**A D D E N D U M**

ADDENDUM No. <b>4</b>		GMCa JOB #: 202113 TDH
ISSUE DATE: 04.25.24		SBC #: 364/011-05-2021
PROJECT: Tennessee Tech University Derryberry Hall – Building Upgrades – Phase I		1 William L. Jones Drive Cookeville, TN 38505
OWNER: Tennessee Tech University		1 Bridgestone Park, 3 <sup>rd</sup> Floor Nashville, TN 37214
ARCHITECT: Gilbert McLaughlin Casella architects		2305 Kline Ave, Suite 200 Nashville, TN 37211

TENNESSEE TECH UNIVERSITY  
**DERRYBERRY HALL**  
 BUILDING UPGRADES - PHASE I  
 1 WILLIAM L. JONES DRIVE  
 COOKEVILLE, TN 38505

ADD-004  
**1 TYPICAL ATTIC FLOOR OPEN FRAME**  
 SCALE: 1" = 1'-0"

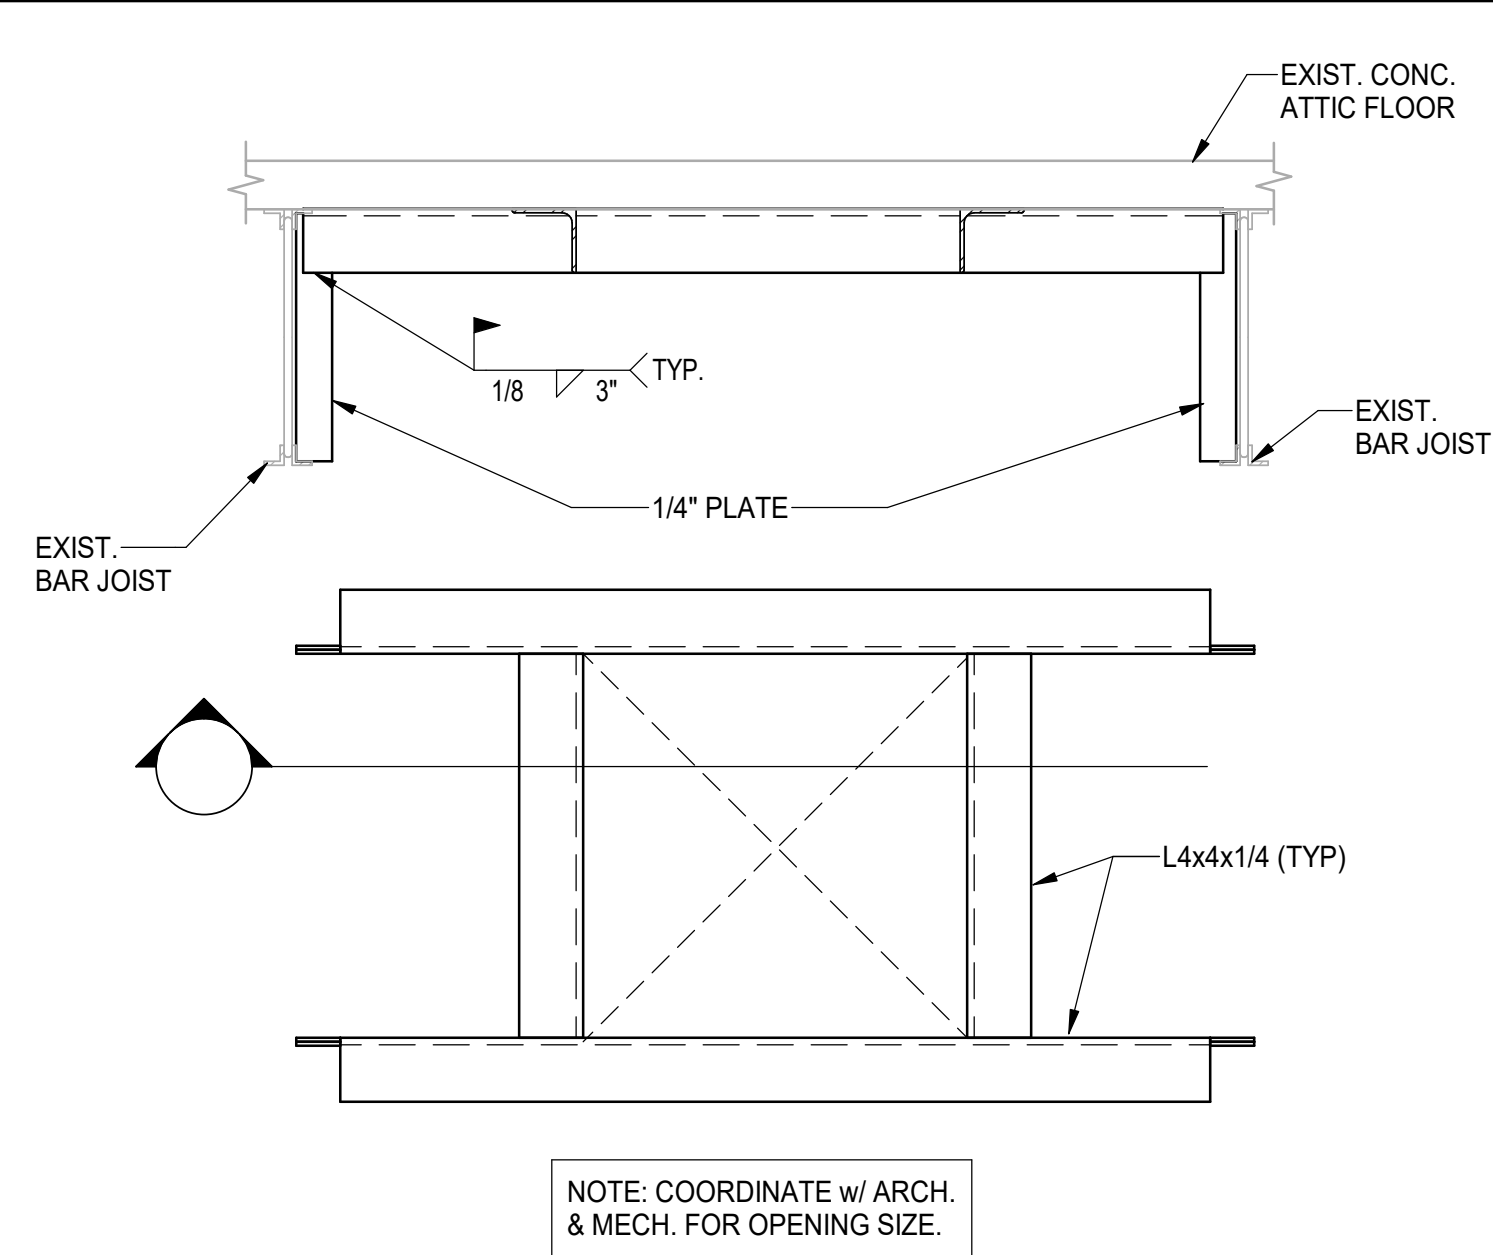
- a) **Per SFM's Comments:** Additional seismic data included.
- 4) S1.2 – Third Floor Framing Plan & Details
  - a) Detail #1 modified & title changed from “Typical Roof Open Frame” to be “Typical Attic Floor Open Frame”.

ADD-004  
**4 SECTION**  
 SCALE: NONE

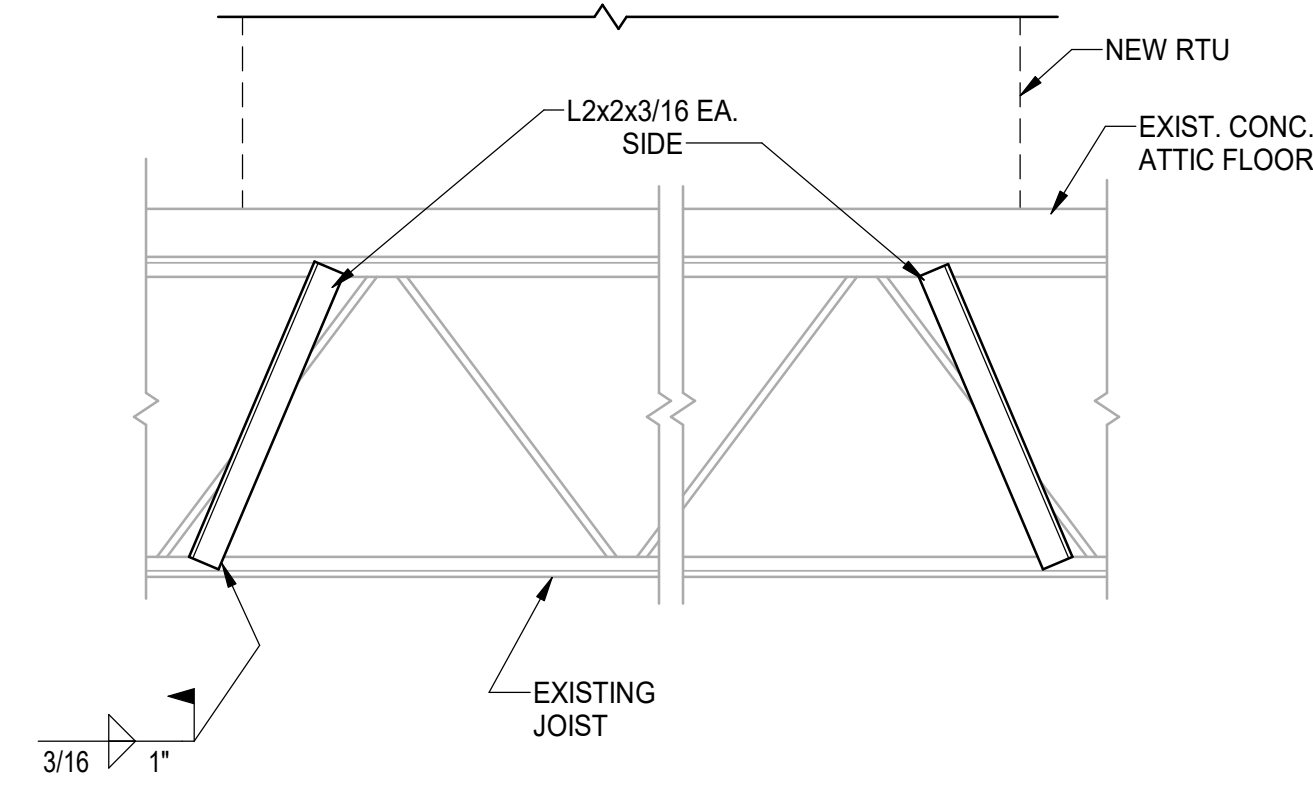
- b) **Per SFM's Comments:** Detail #4 added to show new bracing below mech. equip. in attic.
- 5) S1.3 – Fourth Floor & Attic Framing Plan
  - a) **Per SFM's Comments:** Attic Framing Plan expanded to depict mech. unit & related bracing locations.

PIPE THRU RATED FLOOR DETAIL

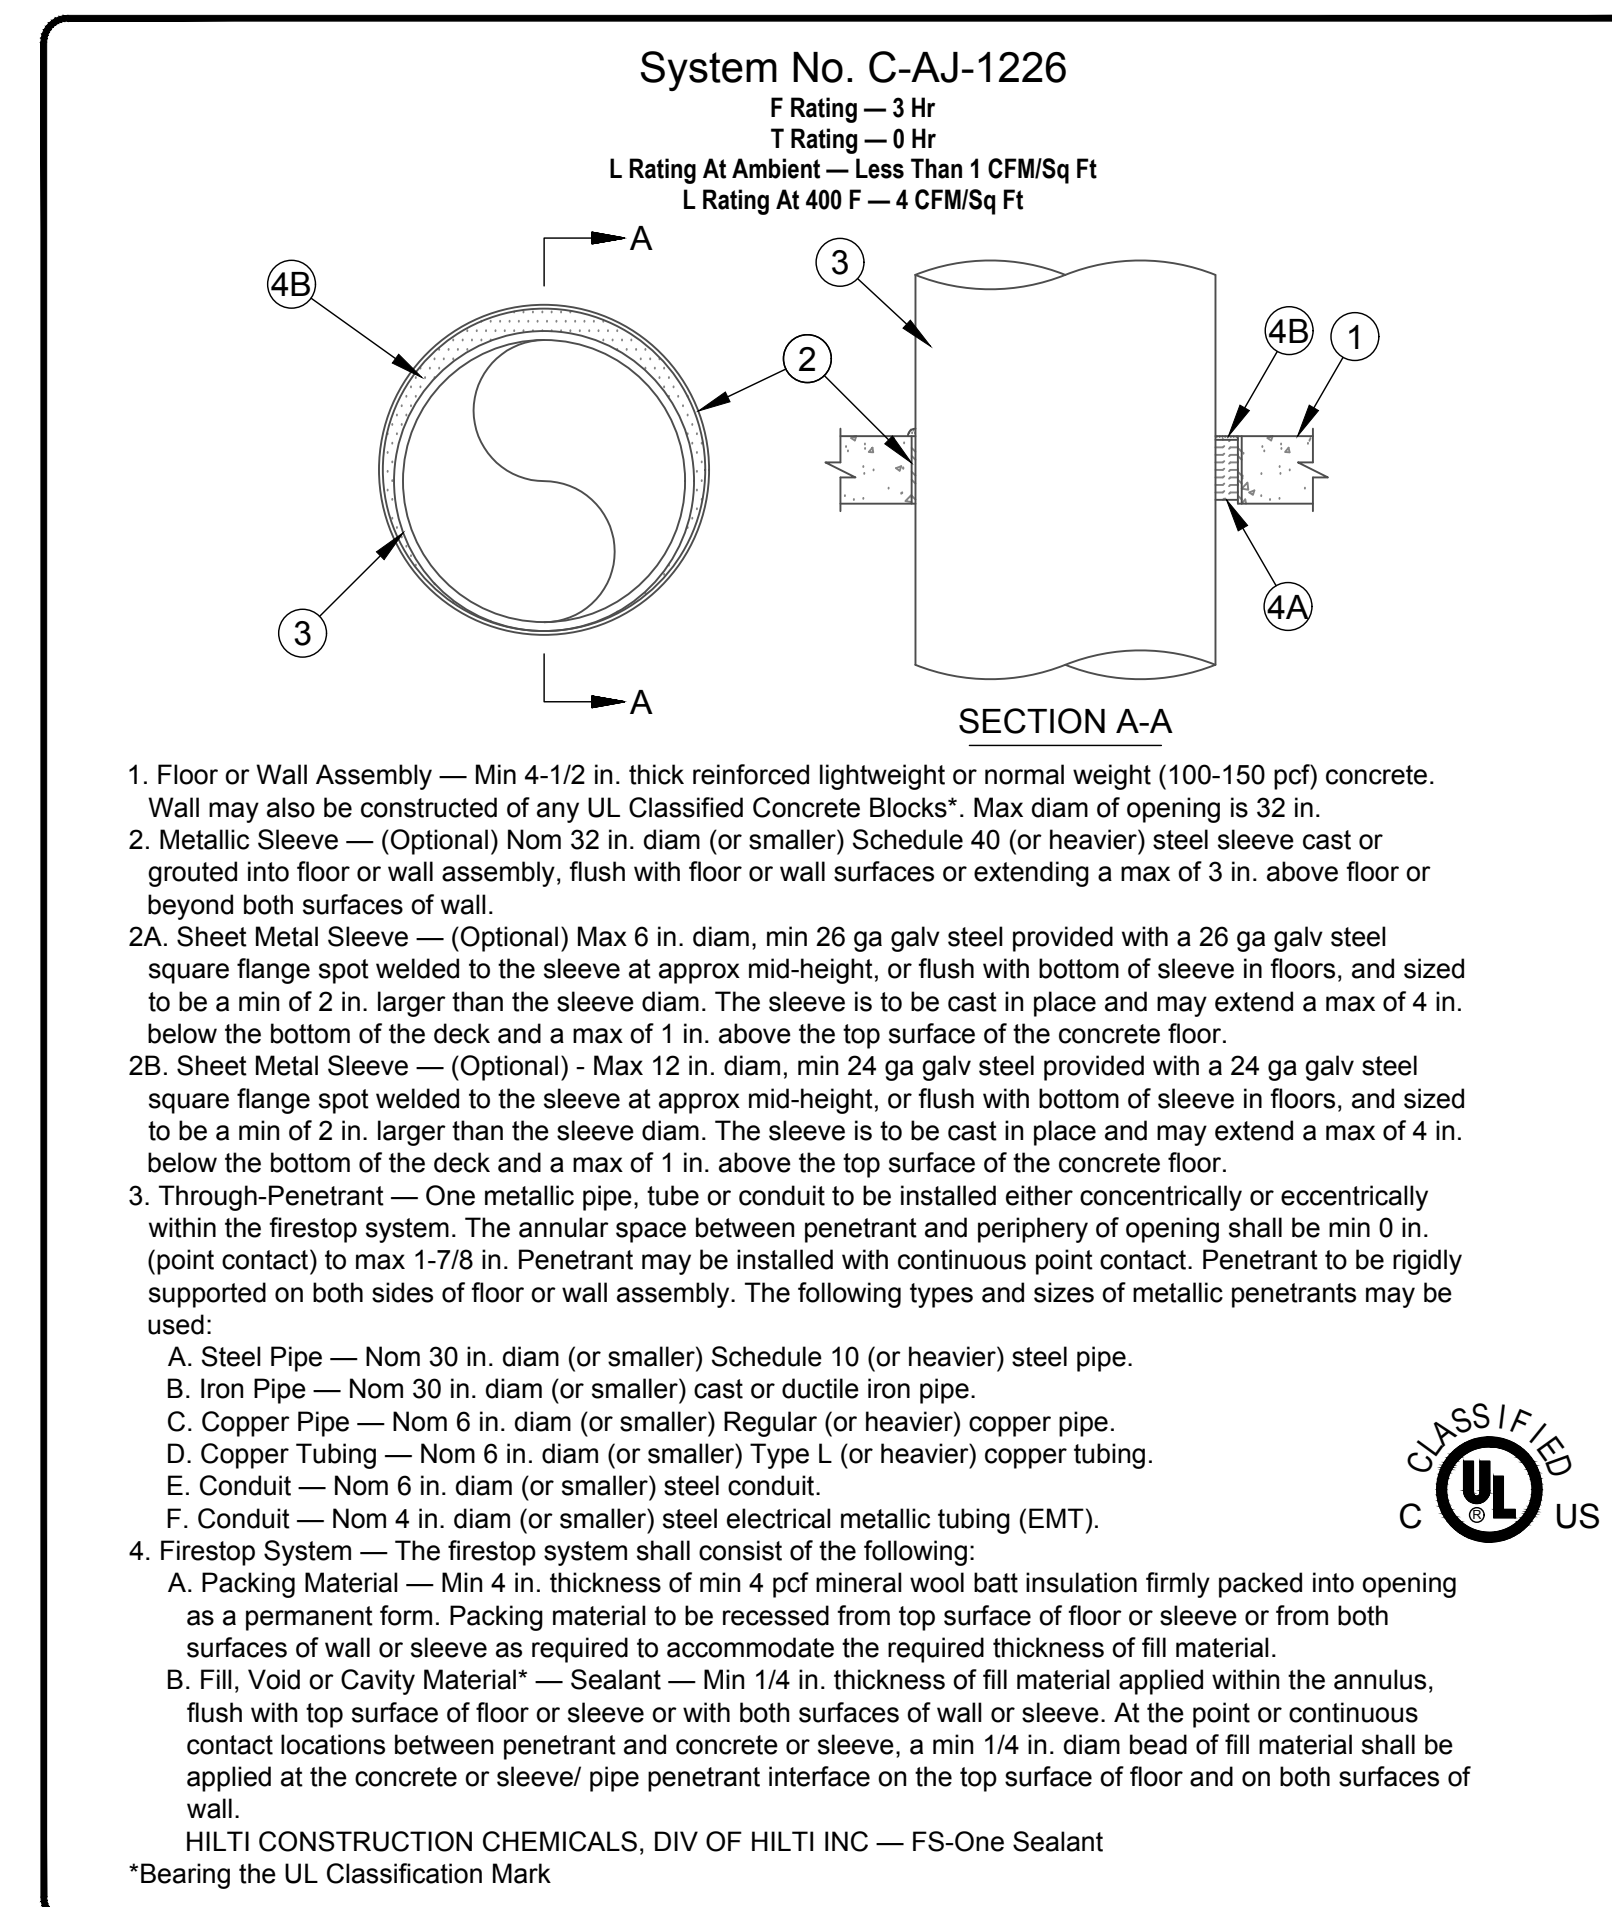
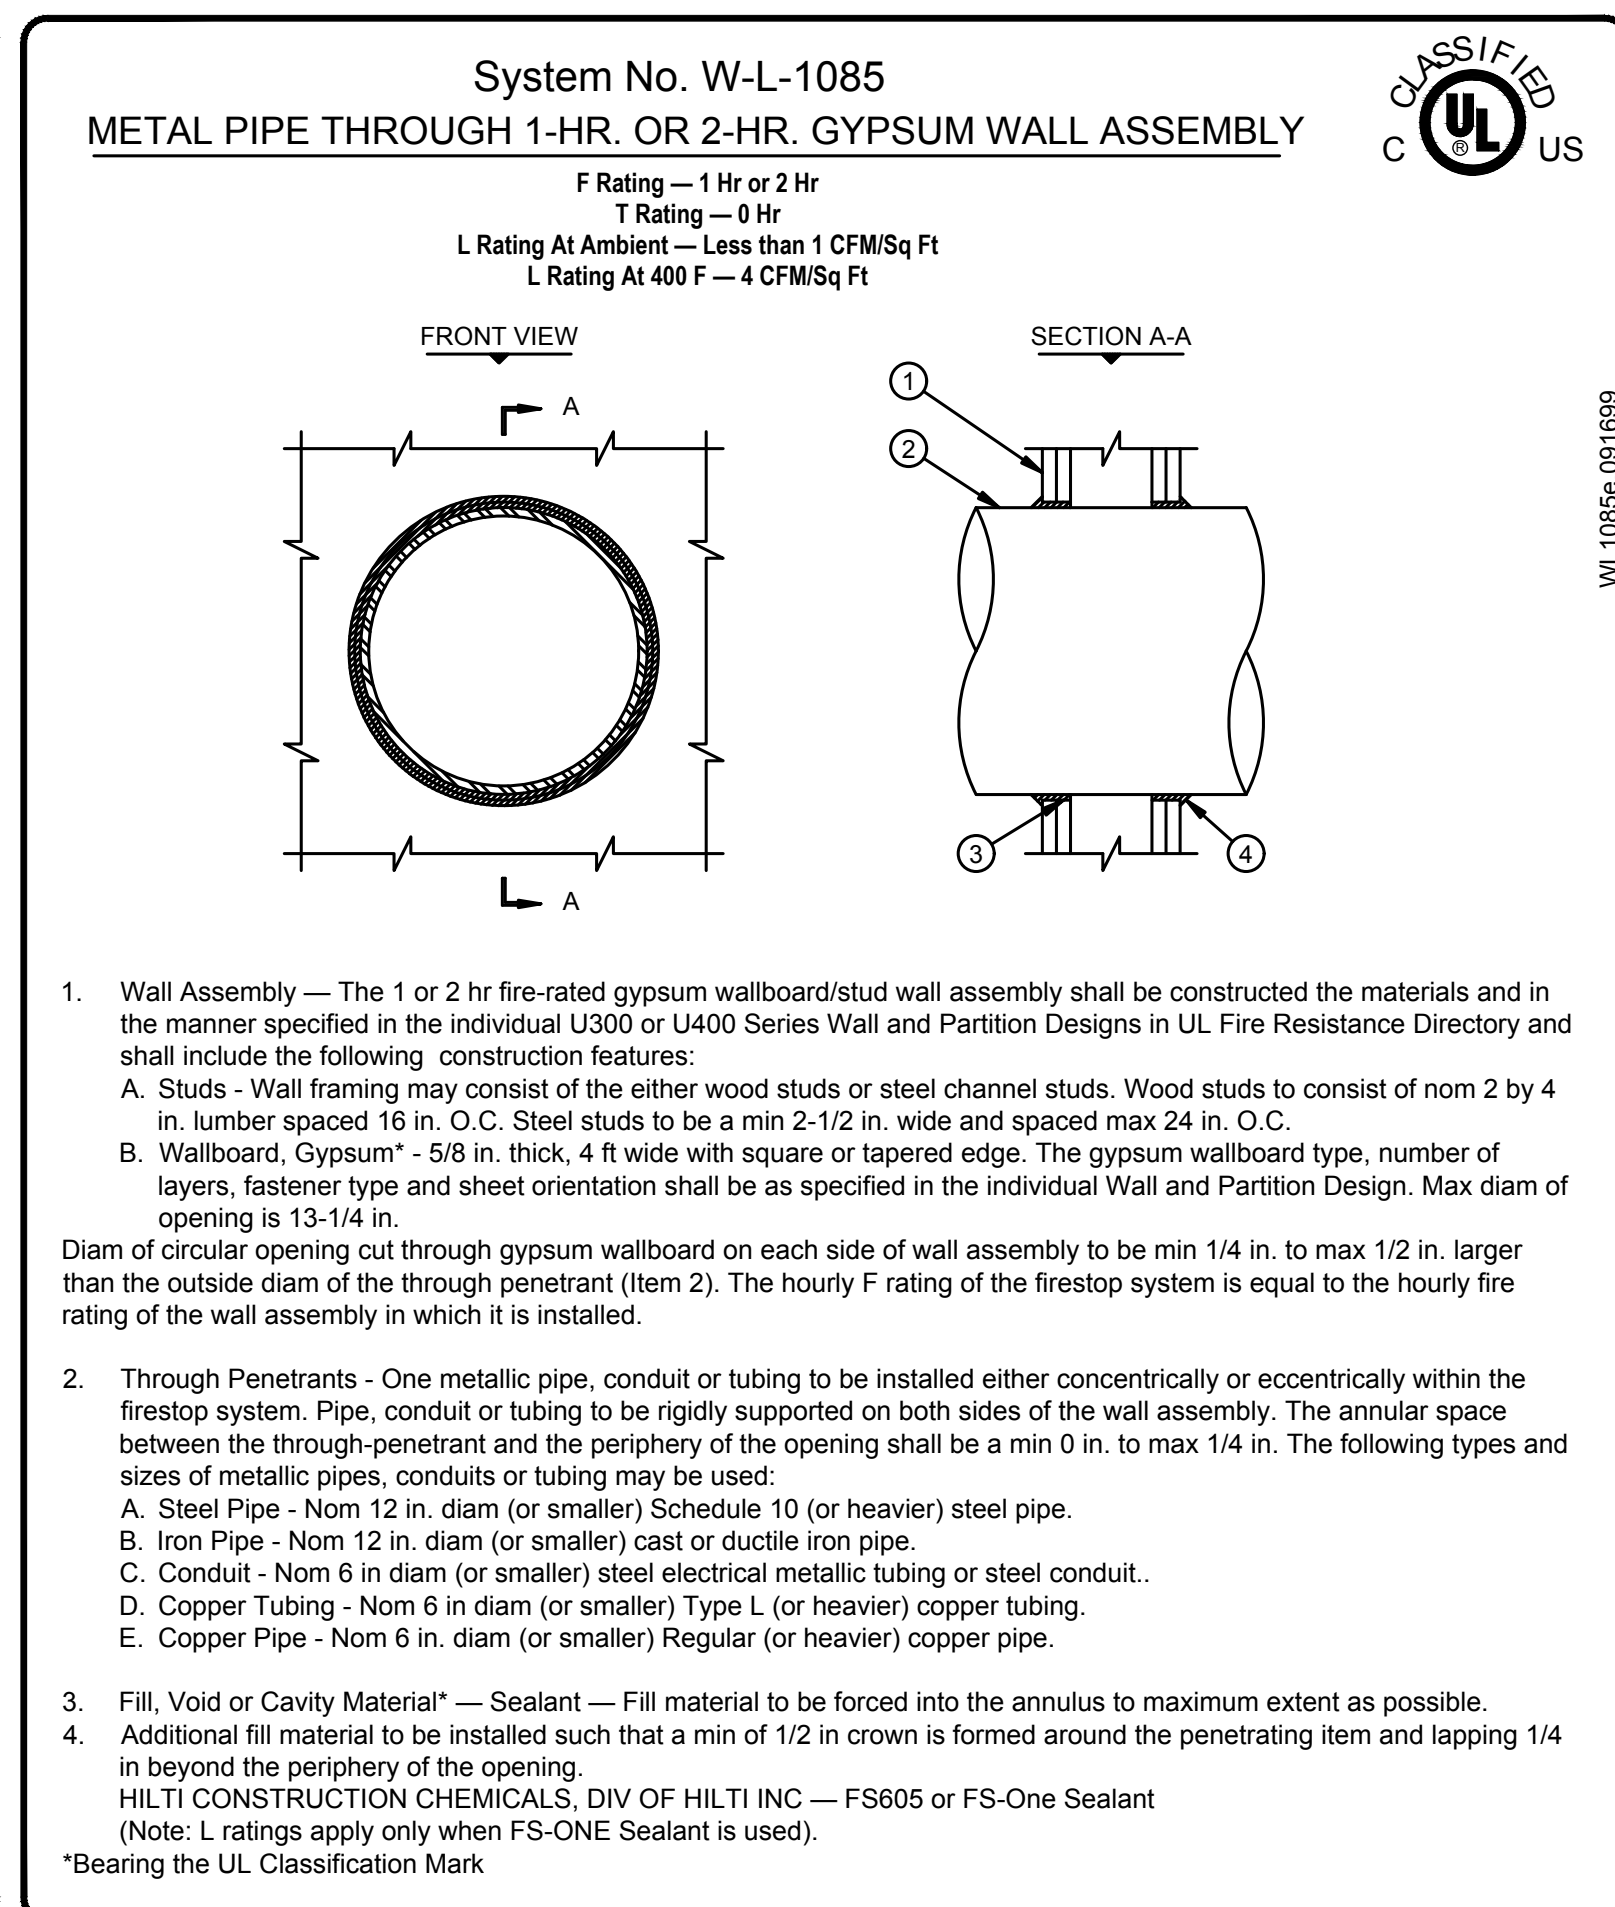
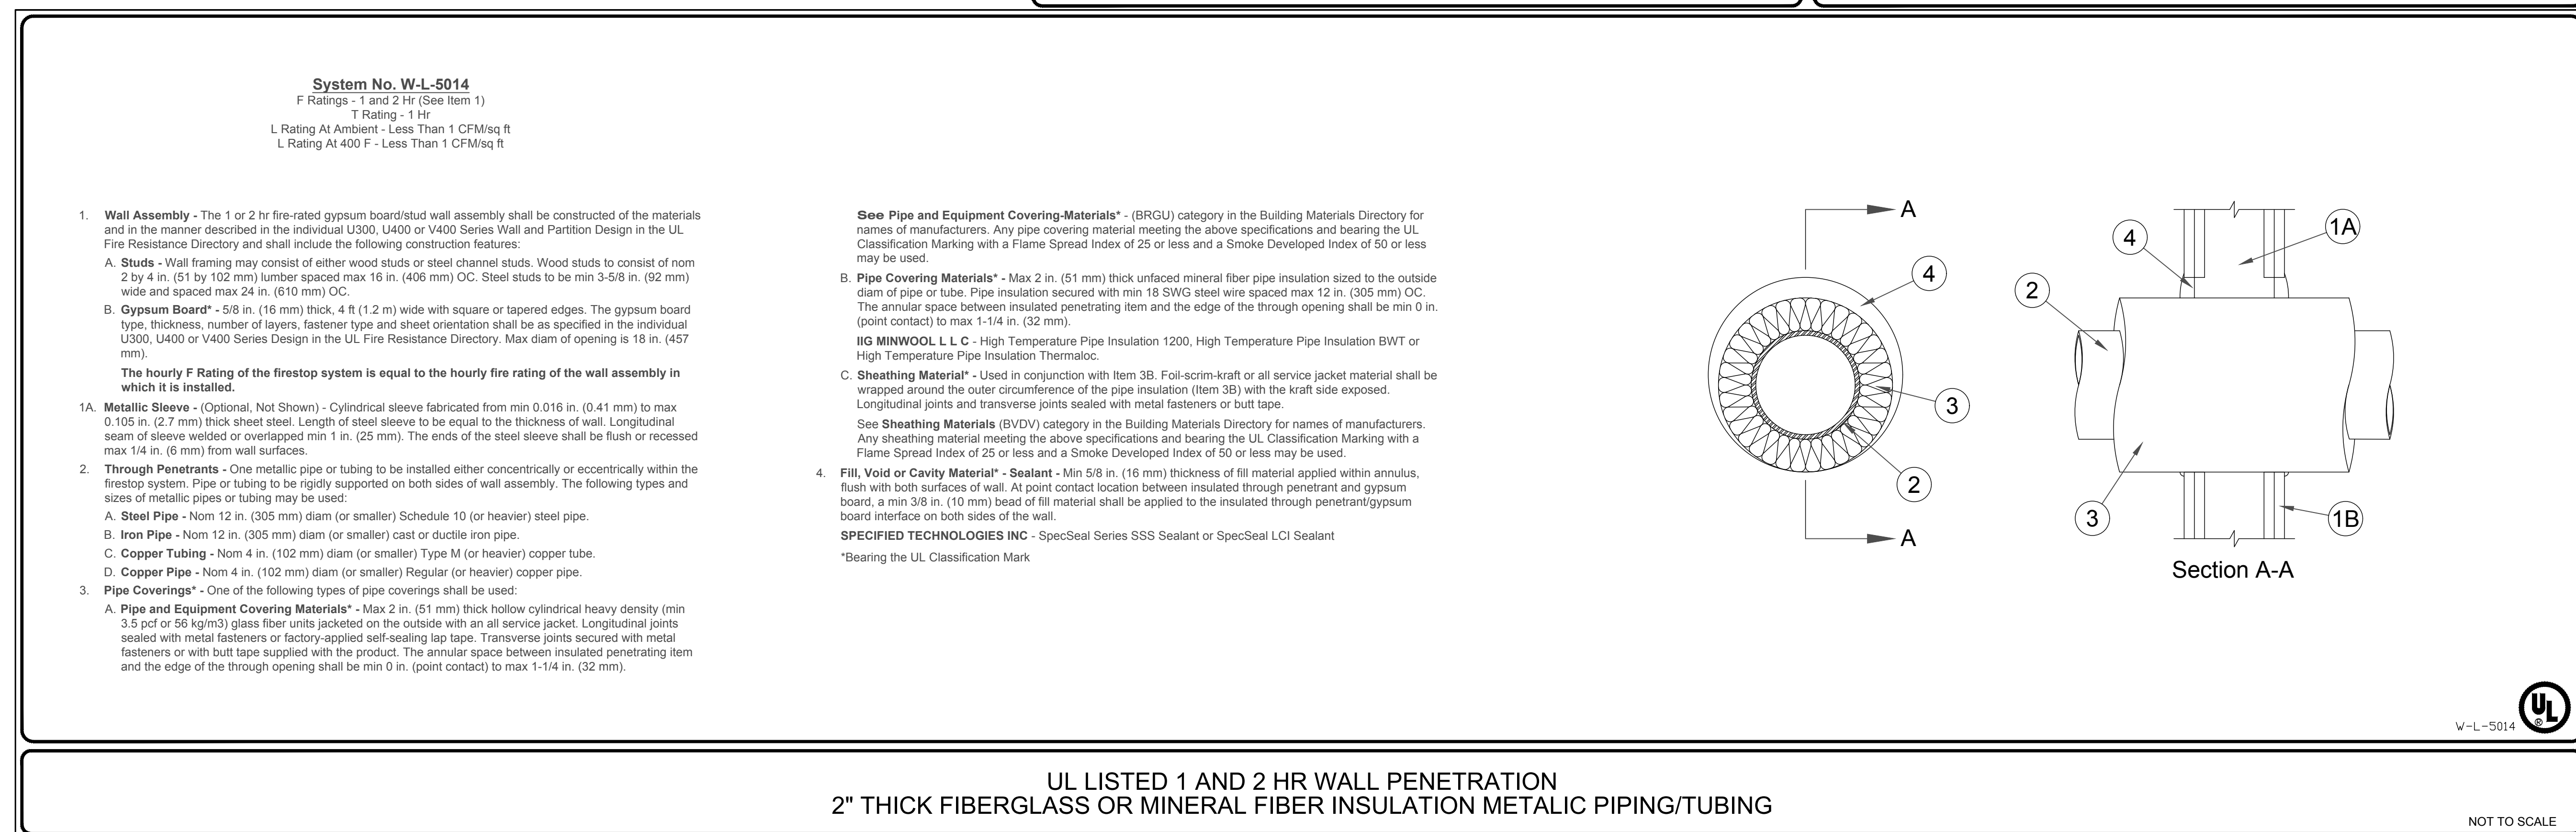
- b) Added chilled water GPM to AHU-03 schedule.
- 8) M3.3 – Mechanical Details
  - a) **Per SFM's Comments:** Sheet added. Contains added UL Details.
- 9) FPO.3 – Fire Protection Notes
